Planning Commission Staff Report

Meeting Date: October 8, 2018

Petition: **P.Z. 08-2018 Homewood Suites (Keller Ventures, LLC)**: A request to amend Ordinance 2916 to establish new permitted uses and development criteria for 7.4 acres of land within an existing “C-8” Planned Commercial District and located at the northeast corner of Chesterfield Parkway West and Hilltown Village Center. (18S540138, 18S540149, 18S540150).

Figure 7: Homewood Suites Site Development Section Plan with easement in green

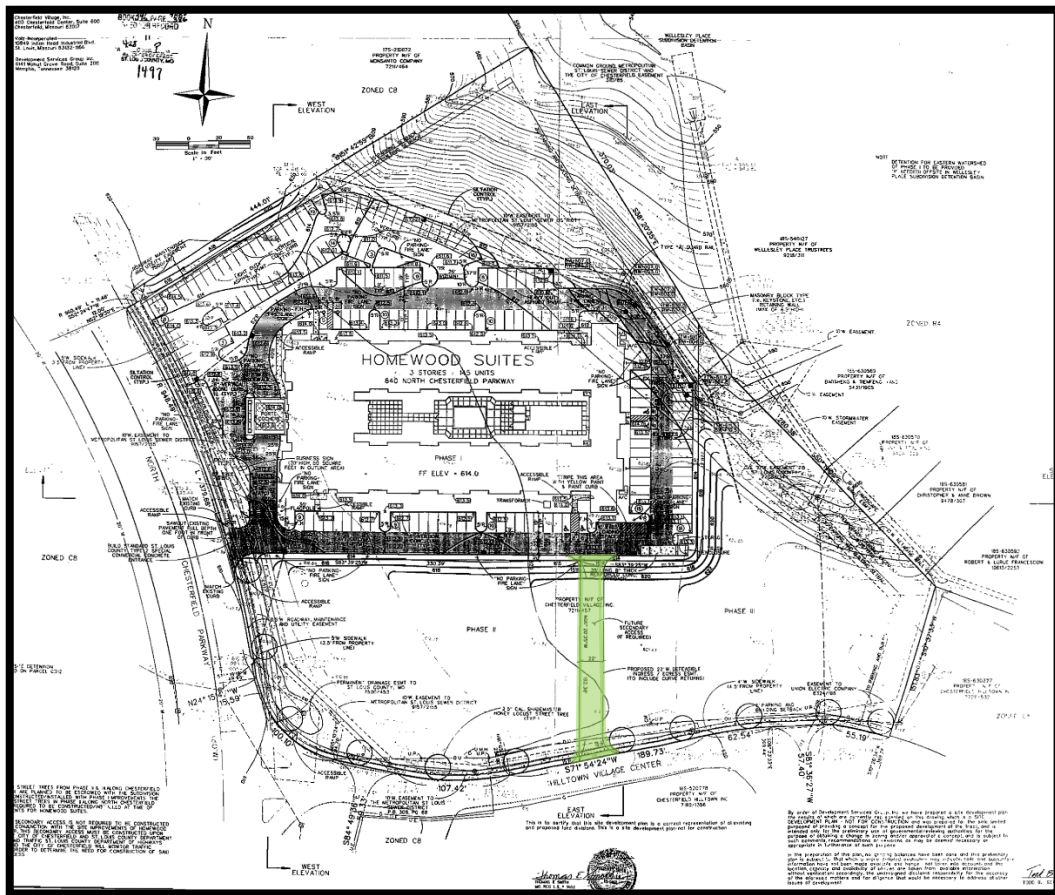
When the Homewood Suites Hotel was approved in 1998, a defeasible ingress/egress easement was shown, along with a potential connection to the hotel as seen in Figure 7.

At the Public Hearing, there was discussion regarding the cross access easement between the Homewood Suites site and Hilltown Village Center to provide better circulation for hotel guests to go south on Chesterfield Parkway. It is Staff's recommendation that the cross access be installed when the next development occurs, whether it is Parcel A or Parcel B. The Petitioner has stated they only wish to install a portion of the cross access, as shown in yellow on the Preliminary Plan. Staff recommends the Planning Commission include a motion to amend the Attachment A to include the following language:

1. *At the time of Site Development Section Plan cross access will be expected between the Homewood Suites Hotel and Hilltown Village Center.*

7. Cross access connecting Parcel C to Hilltown Village Center, as directed by the City of Chesterfield, shall be constructed with the development of either Parcel A or B, whichever comes first.

Response: There is an existing 22' w. ingress/egress easement per PB. 346, Pg. 377, recorded on 6/10/98. A new shared entrance drive at Hilltown Village Center Drive would be constructed by the Developer of Parcel "A" within the existing easement plus the additional width necessary for a 39' wide entrance drive. The Developer, Kiddie Academy, would construct the drive apron to serve Parcels "A" & "B". At this time there is not a project for Parcel "B".
